Project: IEEE P802.15 Working Group for Wireless Personal Area Networks(WPANs)

Submission Title: Proposed resolutions to Dev-Dev comments of LB#87

Re: [802.15 TG4m LB#87]

Figure 22cd—Message sequence chart for broadcast-mode direct data transfer

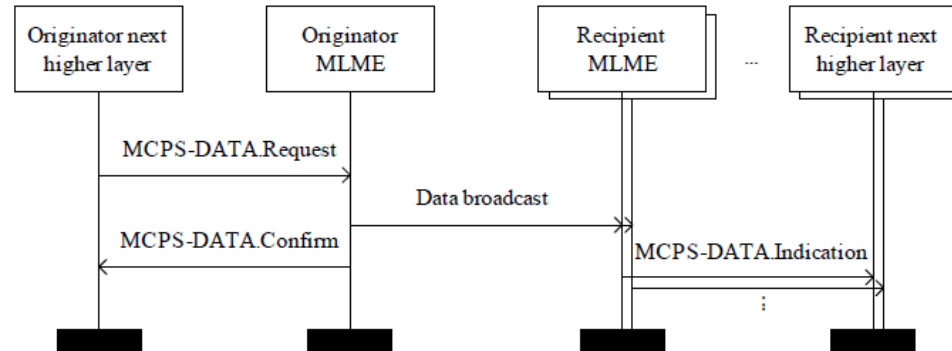
- Comment
 - Broadcast-mode direct data transfer should allow data sent in broadcast to be acknowledged, in order to increase system performance.
- Proposed change
 - Allows a device to send MAC layer data broadcast and request ACK.
- Proposed solutions
 - **Reject**
 - **Acknowledgements to a broadcast data frame may collide. Refer to #108, too.**
